App Ref: 15/00100/FUL
Applicant: Wilton Mills Ltd
Proposal: Erection of Class 1 retail food store & ancillary works etc.
Wilton Mills, 31- 32 Commercial Road, Hawick

Subject: Erection of Class 1 retail unit
Land at Wilton Mills, Commercial Road, Hawick –
15/00100/FUL

**PLANNING APPLICATION: 15/00100/FUL
ERECTION OF CLASS 1 RETAIL FOODSTORE WITH ANCILLARY WORKS
INCLUDING CAR PARKING, ACCESS AND LANDSCAPING
LAND AND BUILDINGS AT WILTON MILLS, 31 - 32 COMMERCIAL ROAD, HAWICK,
SCOTTISH BORDERS**

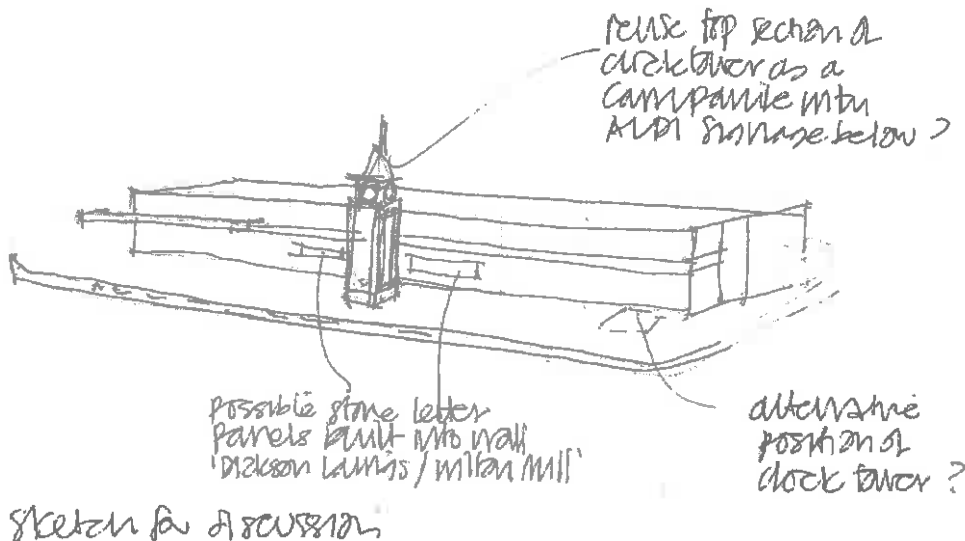
A appreciate that there are certain constraints on the redevelopment of the site, including an approach access point off the trunk road, flooding (which is major issue) and the need for parking and service vehicle access.

The location of the building on the site is largely dictated by the flooding issue as far as I understand; the NE part of the site being naturally higher and therefore requiring less. The proposed building is essentially a standard flat roof "box" with mainly solid walls (and some clerestory glazing) on the more visible walls and solid walls to the rear and far end. Sandstone panels have been incorporated on the more visible walls as cladding, but this could be considered a merely "wallpaper" on a standard box. I appreciate that the internal plan of a supermarket is fairly fixed on a standard layout to suit the particular operator, but there should be more opportunity externally to ensure that the elevation treatment is a response to a particular location. I am not against the use of modern materials or contemporary design but we will need to consider view down on the building from parts of the town as well as from road and pavement level.

I am pleased to see in the Design Statement that it is intended to form a boundary to the front of the site (the plan shows this to include the return up Wilton Lane) in natural stone recovered from demolition to a height of 1200m with railings. No detail of this wall is shown and this should certainly be a condition to consider – I have recommended a linking condition in the proposals for LBC from demolition of the clock tower building, note the comment about the need for LBC for the demolition of the final section of the YM building, this contains stonework capable of being reused for boundary treatment. The boundary treatment to the rear includes some sheet metal piling by the service yard and the boundary treatment to the SW is simply boarding but there appears to be a substantial return of the boundary wall.

Some boulevard tree planting is shown on the plan, but this seems to be omitted in part from the 3D visuals in front of the building. I will leave commentary on the planting proposals to my landscape architect colleagues.

There is a note of the layout plan about a "stone entrance" feature at the junction with Wilton Lane, but no details are provided and there is also a note about a signage board by the main entrance but no details. Conditions will be required for these items. An effort should be made to consider resiting the clock cupola and faces on the site, if not incorporated into the building itself.

No details are shown of the former wheel pit and currently exposed lade system. As a minimum (and subject to LBC), it may be that the wheel pit is carefully infilled (on a separating membrane) and surface paving is used to show the former line and location of the wheel pit. I also consider it necessary to incorporate some form of interpretation board to provide details on the history of the site.

- Samples and details of all materials for elevation treatment of the supermarket will be required.
- Full details, including internal and external elevation and a section of the proposed boundary wall treatment including how the salvaged stonework from the proposed demolition will be incorporated within it shall be submitted and approved in writing by the planning authority. This may incorporate the former lettering "Wilton Mills" from the demolitions. A short section sample of the boundary wall shall be approved by the planning authority in writing.
- Details should be submitted in respect of the all external works, including surface treatment and also proposals for the interpretation of the former mill lade and wheel pit.
